TECHNICAL NOTE

Reference: P0592t01

Re: Westmead Private Hospital, Stage 3 – Responses to Design Excellence Advisory Panel Recommendations

Figure 1: WPH pedestrian desire lines

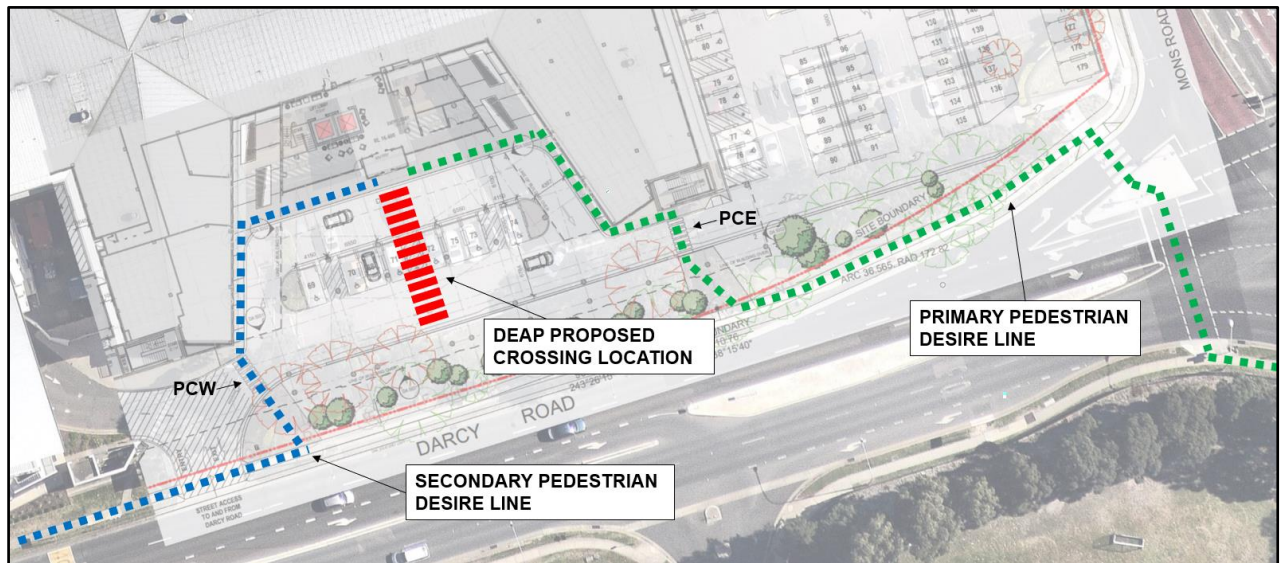
DEAP Recommendation 4. i)

Re-configure the car park layout and provide safe pedestrian access from Darcy Road. The pedestrian entry to the site is currently located adjacent to the existing vehicular access at the western end. The pedestrian entry conflicts with the car movements and the pedestrian entry is poorly signalled in architectural terms. Consider a straight path extending directly from Darcy Road to the front door.

Firstly, the DEAP wording appears to either reference a single pedestrian entry to the site erroneously or ignores the second pedestrian crossing to the east (PCE). The walking catchment, pedestrian traffic generators and public transport infrastructure and facilities are primarily located to the southeast of the site. Therefore, PCE is located along the primary pedestrian desire line as shown in **Figure 1**.

In accordance with Austroads, Australian Standards and RMS policy, both pedestrian crossings are aligned to minimise pedestrian crossing distances and are, as far as is practicable, close to actual pedestrian desire lines. Additionally, the pedestrian crossing at the signalised intersection of Darcy Road / Mons Road / Institute Road provides a centralised location to cross, clear of vehicles waiting at the stop line and this crossing more closely aligns with PCE. This focal point and the absence of safe and viable alternative crossings on Darcy Road for the length of the site further reinforces PCE as a primary crossing facility. Accordingly, PCW will attract significantly fewer pedestrian volumes, minimising conflicts with car movements.

A straight path extending directly from Darcy Road to the front door would not be preferable for the following reasons:

- Crossing distance would increase, resulting in a crossing time that is more than doubled for pedestrians—ignoring the additional 5.4m crossing distance through the accessible parking spaces—increasing the risk of vehicle/pedestrian conflicts.

- Pedestrians would have to cross two internal roads instead of one, effectively doubling any risks.
- The interaction between the accessible spaces and pedestrians would create an undesirable design outcome with an increased potential for conflicts.

- The quantum of accessible parking spaces would need to be reduced to accommodate the pedestrian crossing.
- Increased crossing times would cause longer delays for traffic utilising the drop off zone, parking in the spaces south of the site and driving through to the eastern car park.

- Pedestrians would most likely cross the circulating road of the car park on the desire lines anyway, without the protection of the pedestrian crossings.

- The number of pedestrian/vehicle conflicts would be increased due to the proximity of drop off movements and manoeuvring in and out of the parking spaces to the south of the site.
